RENESAS TECHNICAL UPDATE

Product Category	MPU & MCU	Document No.	TN-16C-A232A/E	Rev.	1.00
Title	Errata to R32C/156 Group User's Manual: Hardware		Information Category	Technical Notification	
Applicable Product	R32C/156 Group	Lot No.	Reference Document	R32C/156 Group User's Manual: Hardware Rev. 1.10 (REJ09B0506-0110)

This document describes corrections to the R32C/156 Group User's Manual: Hardware, Rev. 1.10. The corrections are indicated in red in the list below.

Figure 7.1 Clock Generation Circuitry

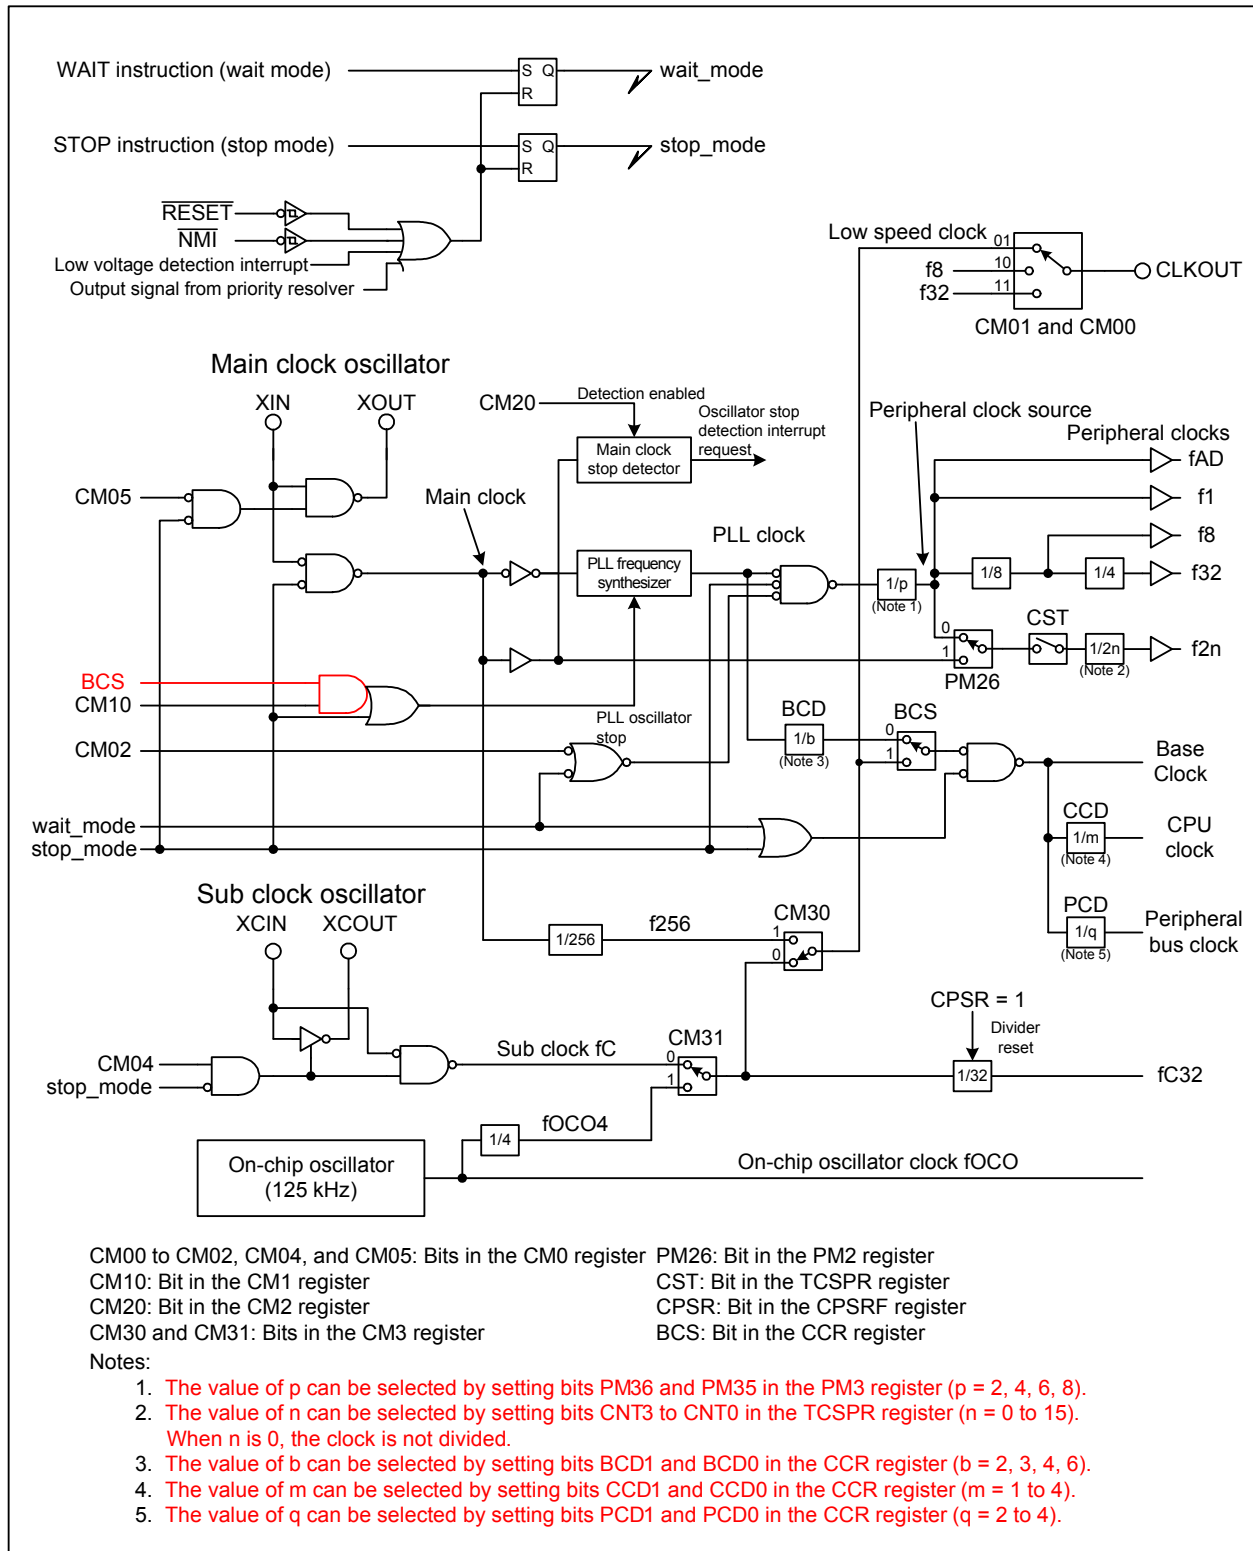
•Page 90 of 625, Figure 7.1 is corrected as follows:

Figure 20.1 CRC Calculator Block Diagram

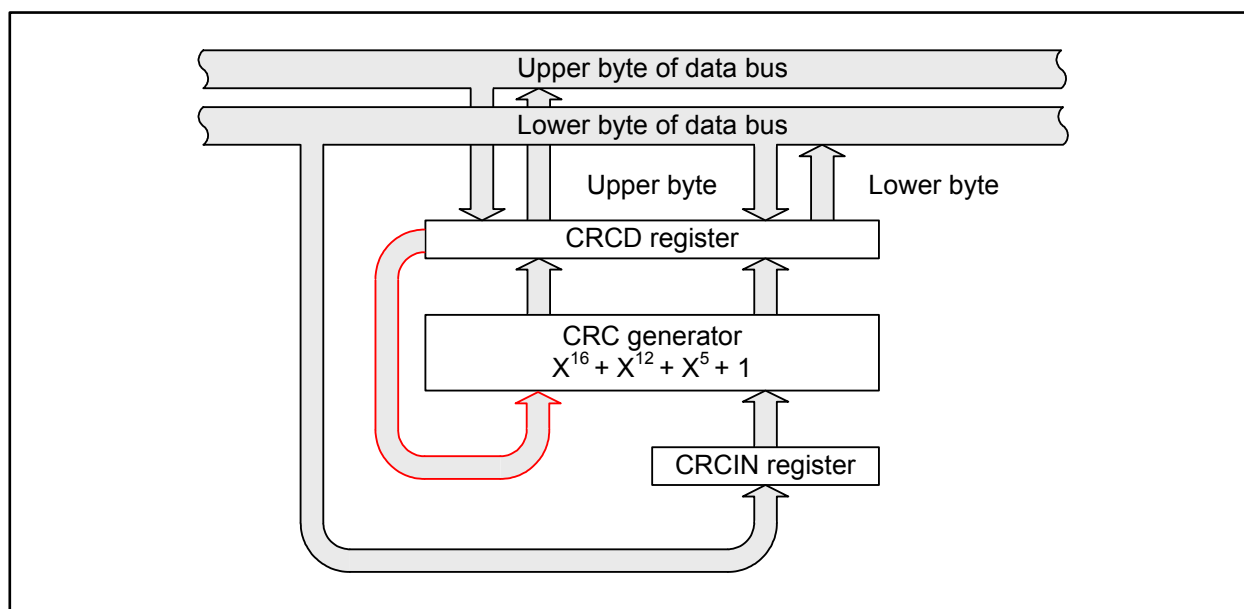
- Page 312 of 625, Figure 20.1 is corrected as follows:

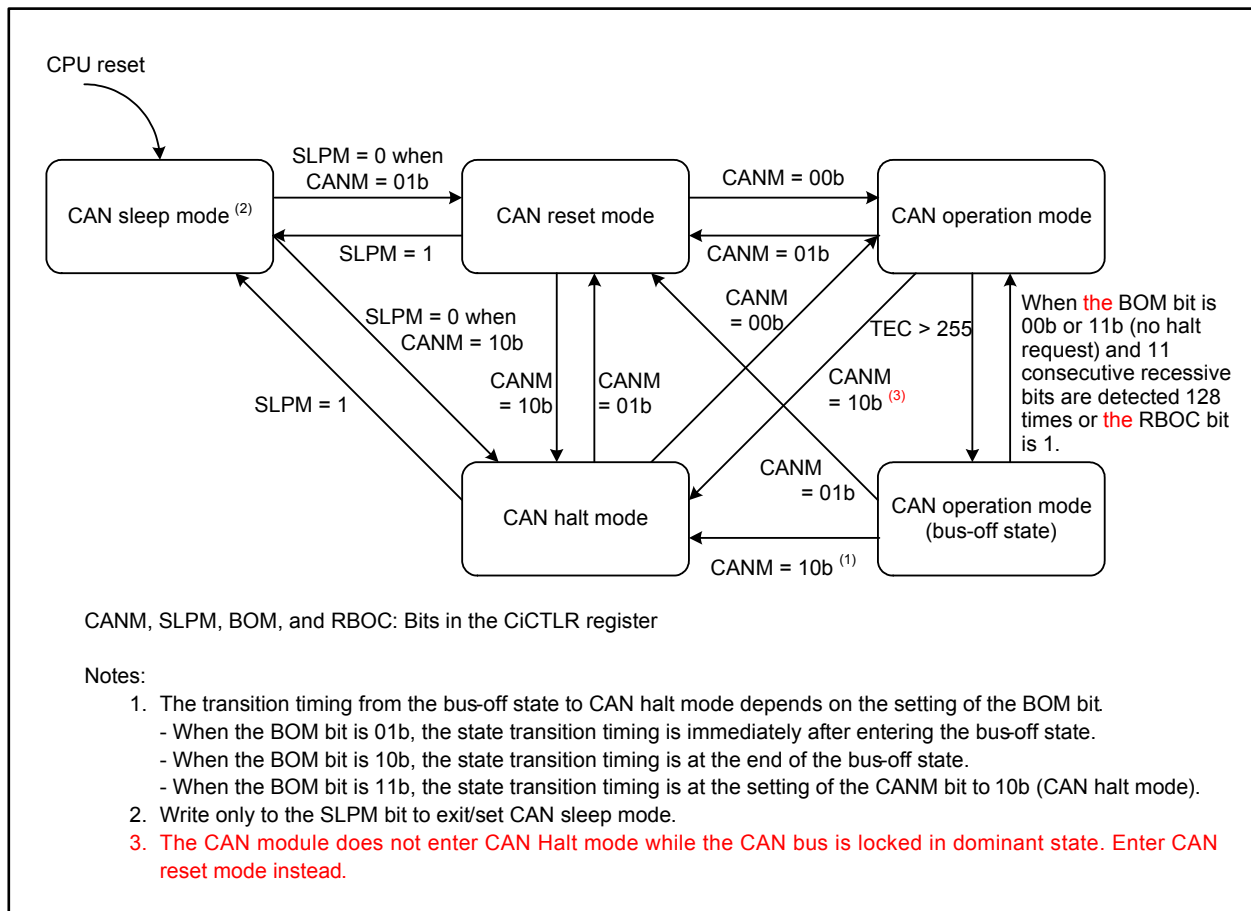
•Page 478 of 625, Note 3 is added to Figure 25.34 as follows (refer to TN-16C-A229A/E):
